Product part number: SLG46200

Active SLG46200 Errata List

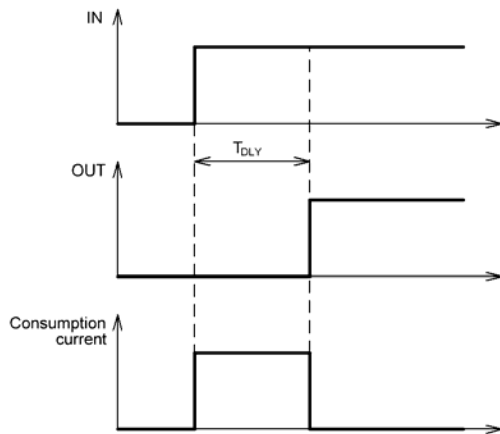
According to the datasheet and specifications ADC PGA has 0.5X gain. However, tested silicon has a measured value of 0.47X.

Use more accurate external voltage dividers.
If the ADC is used with DCMPs, error can be compensated by adjusting the DCMP register numbers.

Normal Delay block (rising edge) functionality

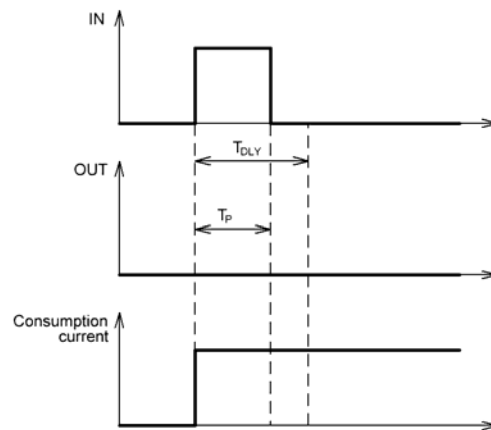
If the delay input pulse duration is less than the delay time (other blocks do not use internal RC oscillator), the output will be correct but the power consumption will stay high. This is due to the delay block that starts RC OSC work after detecting a corresponding edge and then shuts it down after the delay time has passed. If the input signal duration (T_P) is less than the delay time (T_{DLY}), then the RC OSC won't shut down (delay cell will not give the RC OSC shut down signal internally) and the power consumption will go on. If any other delay cell or other block that uses OSC gives a shut-down signal then current consumption will stop.

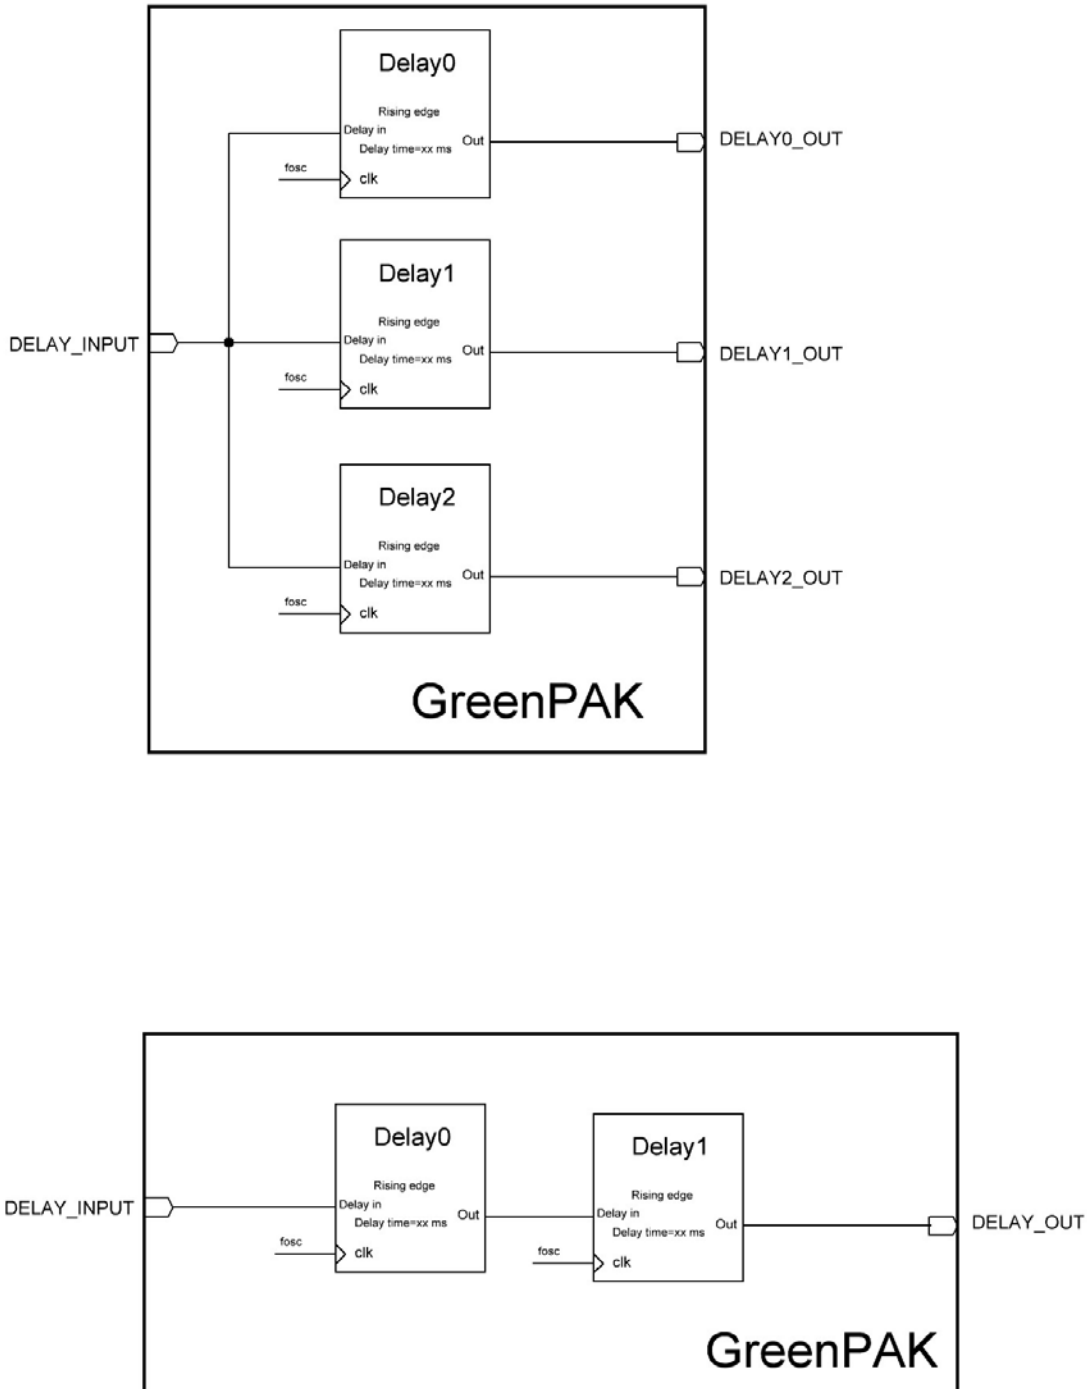
If time between two detected edges is approximately two times less than the delay clock period, then the input signal may pass to the delay output.

As an example the rising edge delay cell test results with internal RC oscillator frequency 43kHz are shown below.

Use two Delay blocks in the series connection.

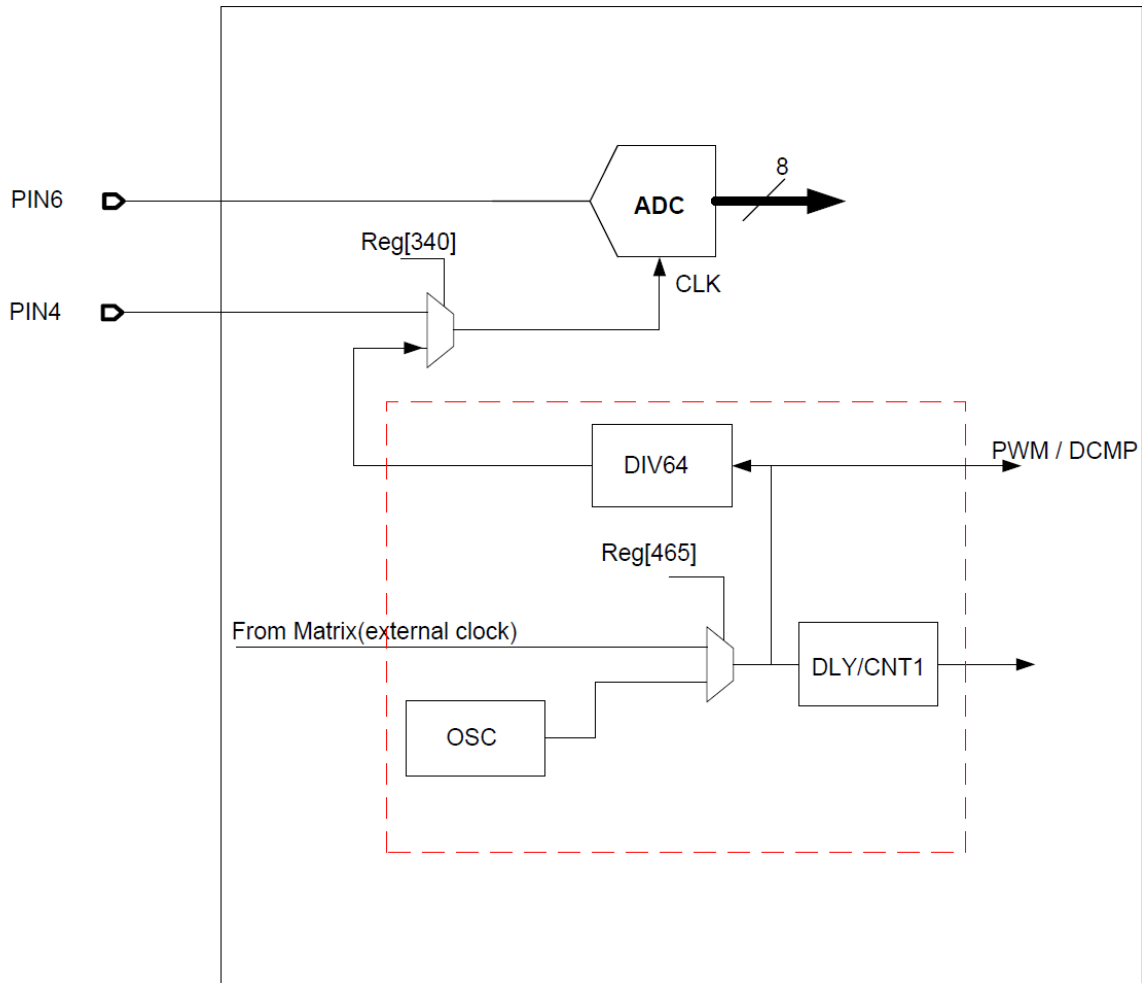
The ADC uses Counter/Delay 1 clock source for sampling data. So if the Counter/Delay 1 clock is not connected, the ADC will not function at all.

Use the internal clock for Counter/Delay 1 for correct ADC functionality.
